Staff Report

Re: PLNHLC2017-00722 – Modifications to New Construction Approval

PROPERTY ADDRESS: 613 E. 100 South

1. Modifications to the South (Front) Façade

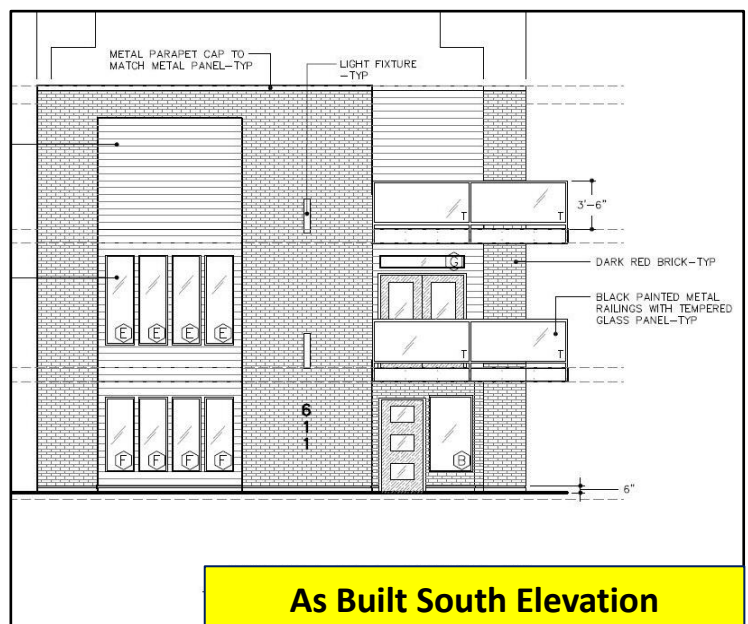
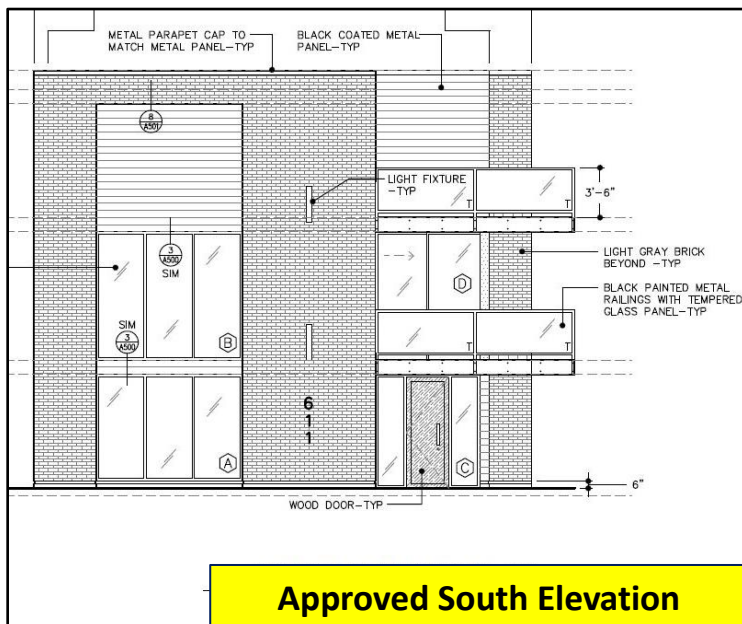
- The two rows of windows on the left building plane have changed in configuration and dimension from a tripartite arrangement (10’4”w x 7’6”- 9’h) to four smaller side-by-side vertically emphasized fixed casement windows (8’6”w x 5’5” - 6’6”h total).
- All of the window material has changed from fiberglass to vinyl

- Different from the door shown on the as built drawing, the front door is proposed to be replaced from the originally approved 9-foot sawn cherry wood door to a 6’8” solid mahogany door with sidelights (see [Attachment B](#) for proposed door). The applicant has explained that the door cannot be any taller due to mechanical equipment in the ceiling.

- Deny the request to change the windows and sliding doors on the front façade
- Approve the request to change the front doorway design and material

2. Modifications to the East (Interior) Façade

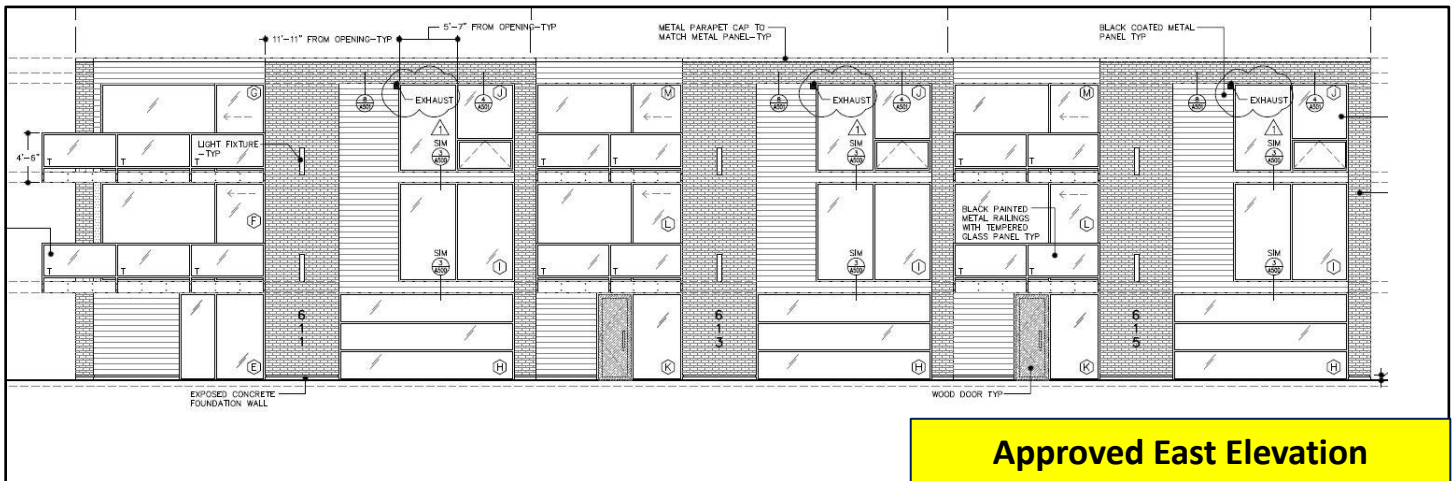
- Recessed building planes - The window/sliding door configuration off of the second and third-level balconies have changed in configuration and dimension to 3-5 side-by-side vertically emphasized casement windows
- Forward building planes - The window arrangements on the three building planes above the garage doors have changed in configuration and dimensions to four side-by-side vertically emphasized casement windows
 - Second level opening changed from 10'6" w x 9' h to 8'6" w x 6'6" h total
 - Third level opening changed from 10'6" w x 8' to 8'6" w x 5'5" total
- The windows beside the two front doors are smaller in height width
- All of the window material has changed from fiberglass to vinyl

- Different from the two doors shown on the as built elevation, the 9-foot sawn cherry wood doors are proposed to be replaced with 6'8" mahogany doors
- The glass panel garage doors are proposed to be replaced with black flat panel steel garage doors (see [Attachment B](#) for all material detail)

- Deny the request to change the windows and doors on the second and third floor of the east façade
- Approve the request to reconfigure the front doorway design and door material on the ground floor of the middle and rear units
- Approve the request to replace the glass panel garage doors with steel panel garage doors

3. Modifications to the West (Interior) Façade

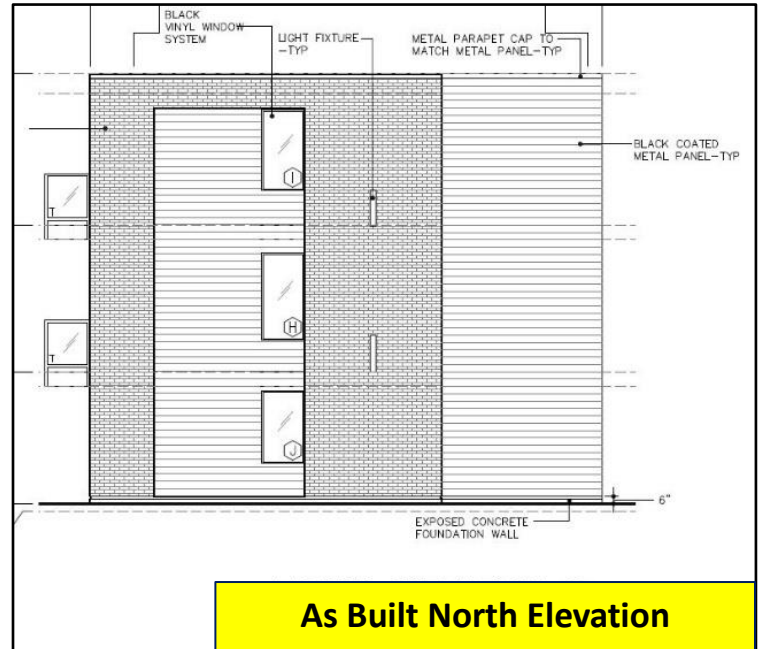
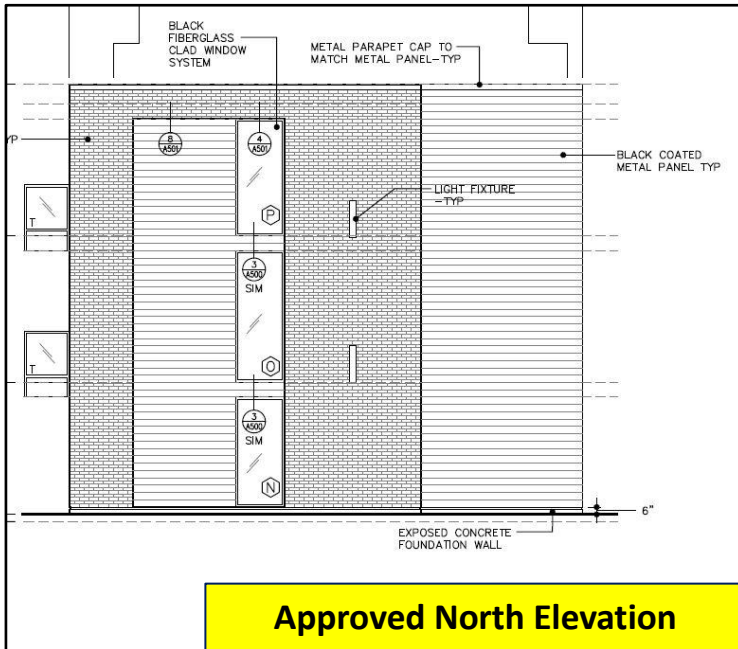
The amount of glass on this west façade has been significantly reduced from the original proposal creating an unbalanced solid to void ratio. This may be more apparent on this façade as it is not as well articulated as the east. The relationship of the width to the height of the windows is not visually compatible with the surrounding structures on the streetscape, which is something that the historic new construction standards require. Because of these reasons, staff is recommending denial of the request to modify the windows on the second and third floor of the building. However, as the back doorways are recessed and not very visible from the public way, staff concludes that reconfiguring the back doorway design would not be detrimental to the character of the rest of the building and is recommending approval of these modifications as proposed on the as built drawings.

- Deny the request to modify the windows on second and third floor of the west façade
- Approve the request to reconfigure the back doorway design and door material on the ground floor of all three units
